Specialty Manufacturing, Inc.

Technical Bulletin #3902A

AIR or VACUUM PUMP REPLACEMENT INSTRUCTIONS

Figure 1

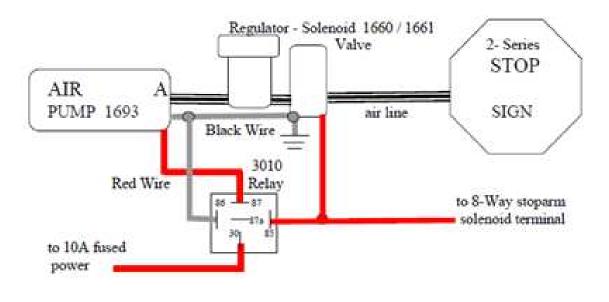
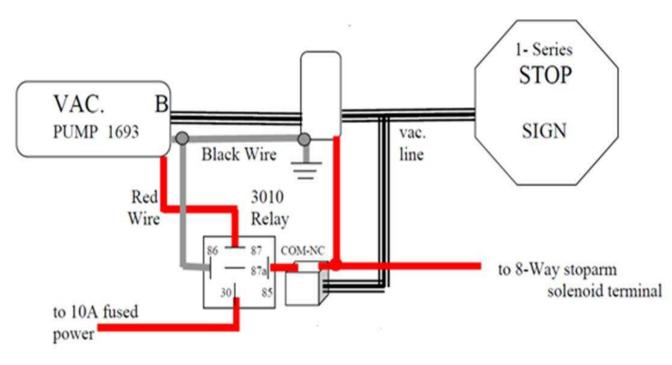
Effective 2/10/93 Air Vacuum Pump (06193) will replace parts 63L©00305 (air compressor) and 63L©00345 (vacuum pump) which are now obsolete. This new design allows the 06193 to be utilized as a vacuum pump <u>or</u> air compressor, dependent on the plumbing configuration. Refer to (Figure 1-air) and (Figure 2-vacuum) for correct plumbing configuration. The recommended mounting location is in the engine compartment of the vehicle on the fire wall or in a position to be bathed in heated air and out of contact with roadway slush to promote satisfactory operation in cold weather.

To illustrate the wiring and tubing schematics (Figures 1 & 2) for part 069193 in conjunction with SMI air stop arms and crossing gates.
